Executive Director's Recommendation

Commission Meeting: May 2, 2019

PROJECT Peace Corps Commemorative Work Reservation 727, Bounded by Louisiana Avenue, NW, First Street, NW and C Street, NW Washington, DC	NCPC FILE NUMBER 7623
SUBMITTED BY United States Department of the Interior National Park Service	NCPC MAP FILE NUMBER 00.00(73.10)44918
REVIEW AUTHORITY Commemorative Works Act per 40 U.S.C. § 8905	APPLICANT'S REQUEST Approval of comments on concept design
	PROPOSED ACTION Approve comments on concept design
	ACTION ITEM TYPE Staff Presentation

Approval of Comments on Concept Design

Tree Plan

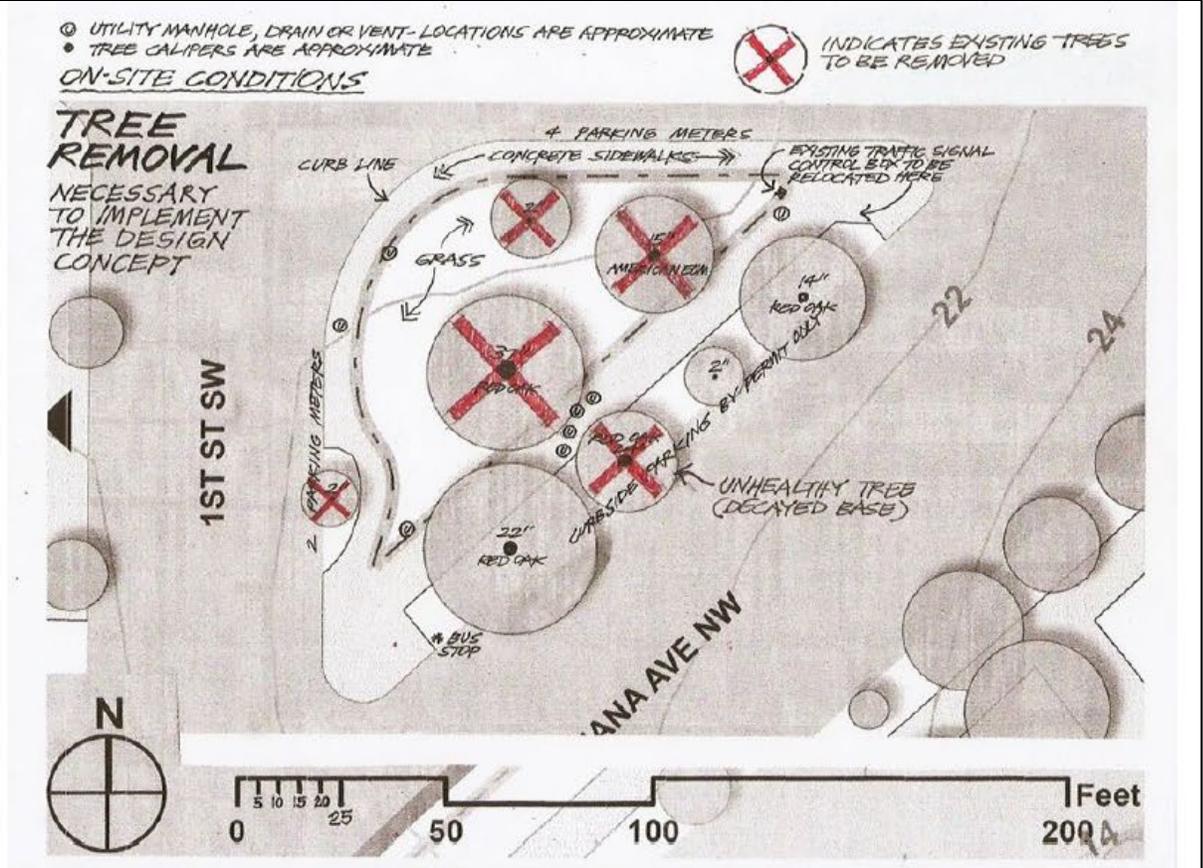
- **Finds** that the concept design proposes the removal of five healthy trees on the site, two of which are relatively large and mature, which is inconsistent with previous Commission comments and would cause undue impacts to the tree canopy. While two new trees are proposed to be planted, this would not mitigate the tree loss or provide adequate shade relief for visitors.
- **Finds** that a large plaza would occupy a majority of the site in the proposed design, which does not provide adequate green space for tree growth or stormwater management, which was an area of concern for the Commission on previous review.

concept design proposes the removal of three larger, mature trees of 15-, 22- and 37-inch caliper, along with two smaller trees of two-inch caliper, for a total of five trees. The 22-inch tree is unhealthy, but the other four are healthy trees. Only two trees would be replanted in the proposed design. One of the smaller trees that would be removed currently obstructs the pathway along the western edge of the parcel. Staff believes that its removal may be unavoidable and could be effectively mitigated through replacement on site. The other small tree could also be mitigated through replacement. The removal of the larger healthy trees, however, are of greater concern.

- **Requires** that the applicant develop a design concept that preserves all “significant trees” of 10 inches in diameter or greater, and that any smaller trees that are removed are replaced at a one-to-one basis. Further, the applicant should seek to retain more green space to enhance stormwater management and maintain a parklike setting for visitors.

Diagram of Commemorative Elements

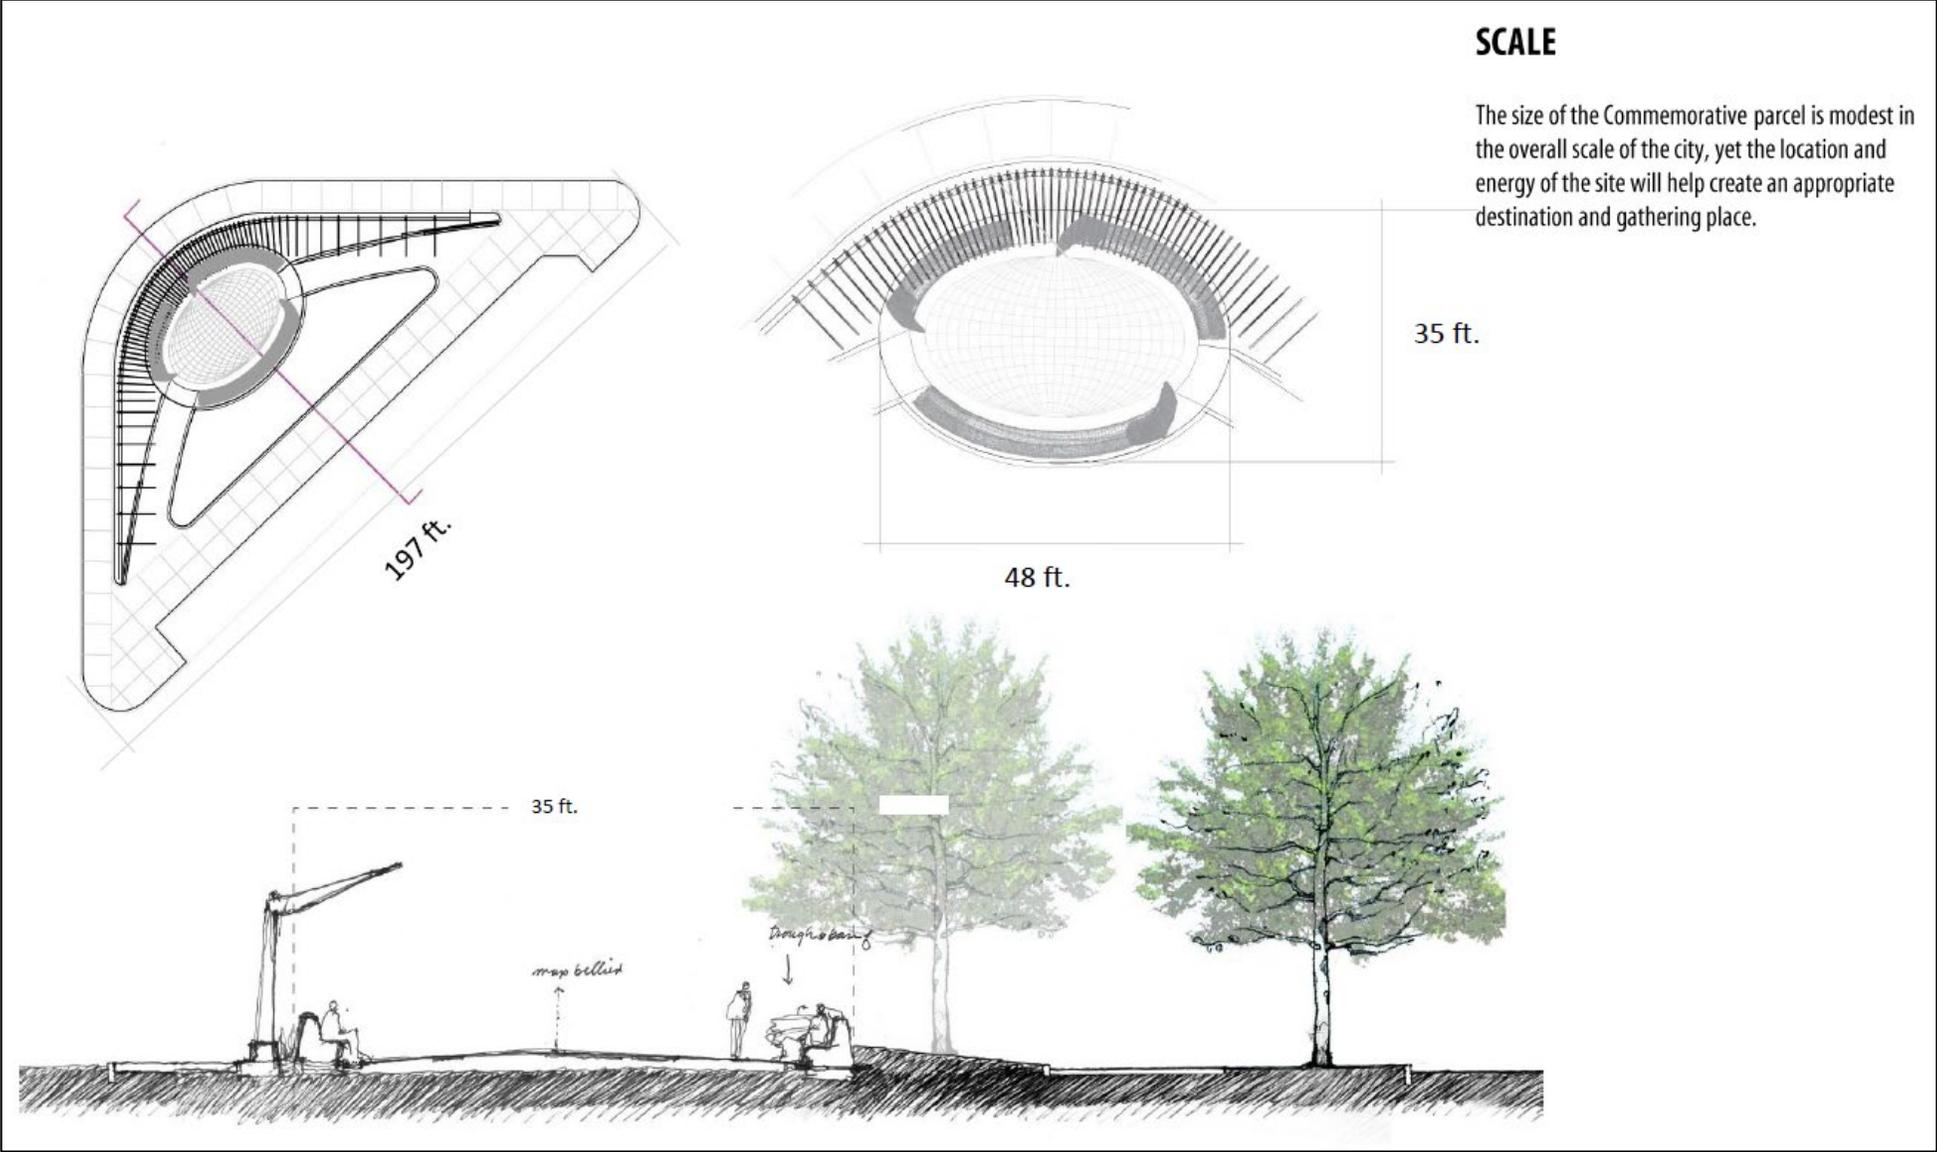
- **Finds** that the height of the proposed pergola and spacing of steel supports could impact views to the U.S. Capitol at this location during certain times of the year, specifically from vantage points west and north of the site at the intersection of 1st and C Streets. The removal of existing trees at the center of the site, as proposed in the site design, would likely increase these impacts.
- **Requires** that the applicant modify the design to ensure critical views are maintained across the memorial site to the U.S. Capitol during all seasons, and provide a visual analysis as part of future submissions that clearly shows the visual impacts of the proposed design on important viewsheds.

- **Finds** that the proposed pergola structure would impede access to memorial from 1st and C Streets, effectively creating a wall along two sides of the site that closes it off from adjacent office uses to the west and north. While the applicant has indicated that this is an intentional design decision, it would restrict pedestrian circulation from adjacent crosswalks to and through the site and may ultimately reduce opportunities for visitors to appreciate the memorial.
- **Requires** that the applicant explore a more welcoming memorial design that allows pedestrian access from all sides, which would allow for better pedestrian circulation and improve the visitor experience.

Plaza benches/hands: They expressed appreciation for the organic form of the benches in general, but raised concern about the surreal quality of the hands, suggesting perhaps a more abstract approach to the sculpted ends of the benches. They also suggested reducing the number of benches from three to two, and encouraging pedestrian movement past the benches into the north and west edges of the site.

Canopy structure: Observing that the overall effect of the posts together is to create a barrier, they recommended refining the shape and spacing of the canopy posts to make the array more visually open and less fence-like, possibly allowing pedestrians to pass through it. For the glass blades supported by the posts, they recommended making these larger and more flag-like, with a billowing gestural effect and more range of color. They also recommended greater consideration of the array from the north and west, suggesting that the canopy's glass and lighting be extended outward in order to allow the memorial to present itself in all directions.
